Form 3160-5
(June 2019)

2. Name of Operator MEWBOURNE OIL COMPANY

8. Well Name and No. FORTY NINER RIDGE UNIT/132H

Mewbourne Oil Company requests approval to make the following changes to the approved APD:

WELL LOCATION AND ACREAGE DEDICATION PLAT

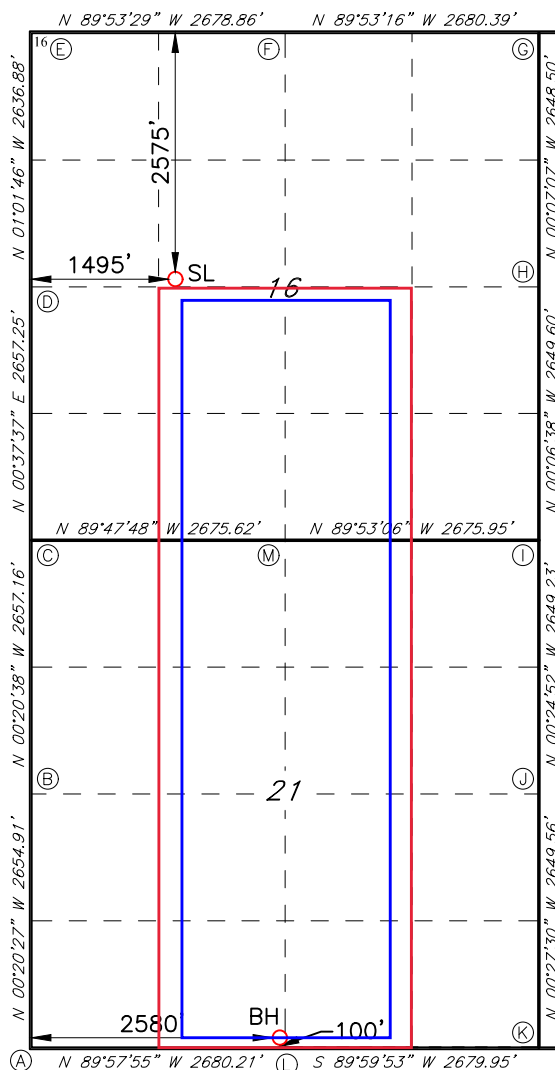
1) Change SHL from 2575' FNL & 1425' FWL, Sec 16, T23S, R30E to 2575' FNL & 1495' FWL, Sec 16, T23S, R30E

2) Change pool from Wildcat Wolfcamp (98268) to Forty Niner Ridge Bone Spring (24720) and target zone from Wolfcamp to Harkey Shale

UL or lot no.	Section	Township	Range	Lot Idn	Feet from the	North/South line	Feet From the	East/West line	County
F	16	23S	30E		2575	NORTH	1495	WEST	EDDY

3-String Design – Open Production Casing Annulus

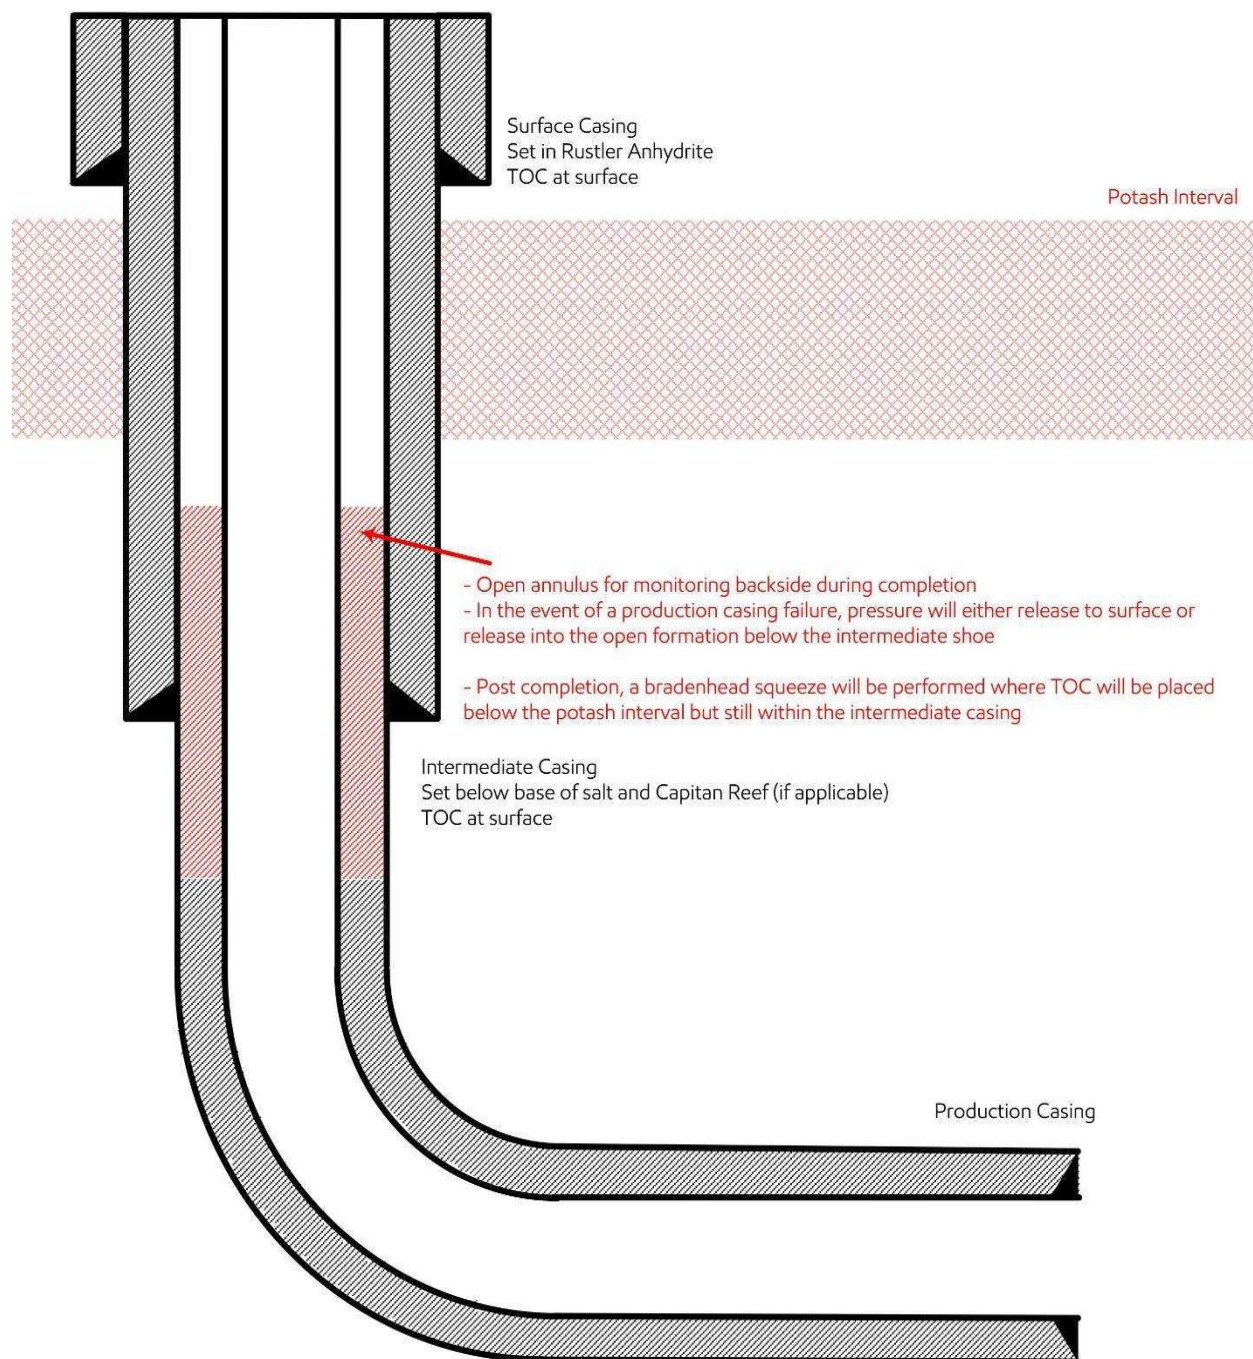
- i. A monitored open annulus will be incorporated during completion by leaving the 1st Intermediate Casing x Production Casing annulus un-cemented and monitored inside the 1st Intermediate String. Reference wellbore diagram.

- i. The top of cement in the Production Casing x 1st Intermediate Casing Annulus shall stand uncemented at least 500' below the 1st Intermediate Casing Shoe. Zero percent excess shall be pumped on the Production Cementing Slurry to ensure no tie-back into the 1st Intermediate Casing Shoe.

- ii. After Stimulation Operations have been concluded and no longer than 180 days after the well is brought online, the operator will be responsible for Bradenheading cement to ensure at least a 500' tie back has been established inside the 1st Intermediate (Salt String / Capitan String) but not higher than Marker Bed No. 126 (base of the Potash mining interval).
